Title: Advisory Committee on Reactor Safeguards
Thermal Hydraulics Phenomena Subcommittee

Date: Tuesday, June 22, 2004

4 ADVISORY COMMITTEE ON REACTOR SAFEGUARDS
5 THERMAL HYDRAULICS SUBCOMMITTEE

Figure 3-3. Nukon Transport Logic Tree (Sample Problem)

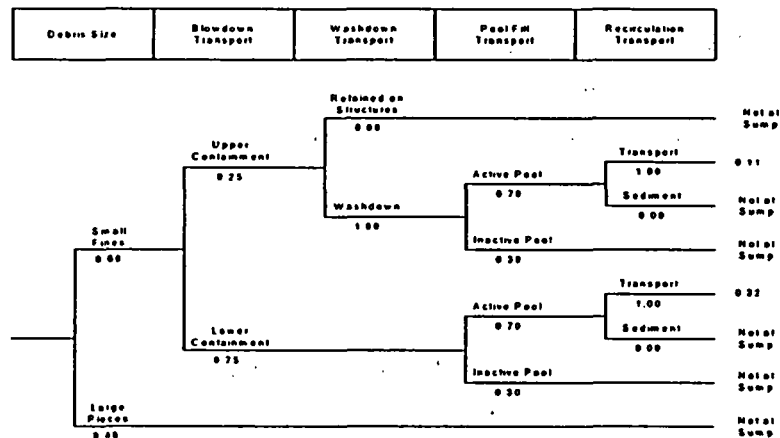
6 MR. ANDREYCHEK: If the zone of influence
7 for Nukon alone, okay? Now, you'll find that there's
8 another logic tree like this for reflective metallic
9 insulation for the same plant design that has slightly
10 different numbers perhaps based on what's generated as
11 large and small fines.

12 MEMBER KRESS: So you add up all of the
13 logic tree.

19 CHAIRMAN WALLIS: Now, who is going to do
20 this calculation? Are the individual plants going to
21 do it or are they going to hire a consultant who knows
22 what he's doing?

23 MEMBER FORD: And my question to
24 Professor's Wallis' question: who is making those
25 judgments? Is it an expert panel or is it a youth?

6 CHAIRMAN WALLIS: But this is again -- the
7 question is how well equipped the staff is going to be
8 to evaluate these assumptions and judgments.

6 MR. ANDREYCHEK: This particular
7 methodology, the direction I was given was make it in
8 such a way that the engineer could plan, pick up and
9 read it, and use it.

4 MR. ZIGLER: -- looking at the available
5 data in previous analysis, and dividing this whole
6 spectra over which we have plans, where we see three
7 basic categories.

8 That is, the ice condenser transport logic
9 tree for the baseline, and what we call the highly
10 compartmentalized plants which Tim addresses as the
11 early generation plants, and then the non-highly
12 compartmentalized plans which are the latter
13 generation plans on it.
